Access Compliance Report

Public Rights-of-Way

(Curb Ramps)

Intersection ID: 48311	Main Street: TRILLIUM_FIELDS_DR	Cross Street: GREEN_CLOVER_DR	Location: SE
ADA ID: 39A267419E28	Ramp Type: BlendTrans1	Initial Pass/Fail: Fail	Overall Compliance: No
		Severity Score: 10

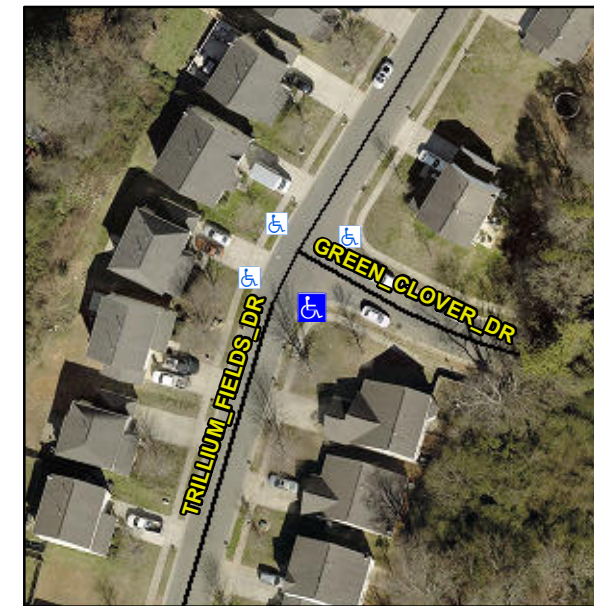
Not Found, R304.5.1, R304.5.3

Compliance	Description	Data	Compliance	Description	Data
N/A	Ramp Length (in)	48.0	Yes	BlendTrans Slope (%)	2.8
No	Ramp Width (in)	47.0	No	BlendTrans XSlope (%)	2.1
N/A	Flare Type LT	N/A	N/A	Flare Type RT	N/A
N/A	Flare Slope LT (%)	N/A	N/A	Flare Slope RT (%)	N/A
N/A	Flare Traversable LT?	N/A	N/A	Flare Traversable RT?	N/A
N/A	Landing Length (in)	N/A	N/A	DWS Provided?	N/A
N/A	Landing Width (in)	N/A	N/A	DWS Contrast?	N/A
N/A	Landing Slope (%)	N/A	N/A	DWS Length (in)	N/A
N/A	Landing X Slope (%)	N/A	N/A	DWS Full Width?	N/A
N/A	Landing Curb? (Y/N)	N/A	N/A	DWS Offset (in)	N/A
N/A	Shared Landing?	N/A			
N/A	Gutter Ponding?	N/A	N/A	Gutter Slope (%)	N/A
N/A	Gutter Lip Ht (in)	N/A	N/A	Gutter X Slope (%)	N/A
N/A	Painted X Walk1?	No	N/A	Painted X Walk2?	No
	X Walk 1 Direction	To N		X Walk 2 Direction	To W
	X Walk 1 Width (in)	N/A		X Walk 2 Width (in)	N/A
	X Walk 1 Slope (%)	0.1		X Walk 2 Slope (%)	3.3
	X Walk 1 X Slope (%)	0.5		X Walk 2 X Slope (%)	1.8

N/A	Ramp inside XWalk1?	N/A	N/A	Ramp inside XWalk2?	N/A
	Road Slope (%)	0.9		Clear Space?	N/A
	Road X Slope (%)	0.9	N/A	Clear Space to XWalk (in)	N/A
N/A	Any Obstructions?	N/A	N/A	Storm Grate/Utility Hazard?	N/A
	Obstruction Type			Storm Grate/Utility Type	
		N/A			N/A
			Yes	Surface Condition? (G/P)	Good
			No	Curb Slope (%)	12.4

Remove & Replace Curb Ramp With Two New Directional Ramps or Equivalent.
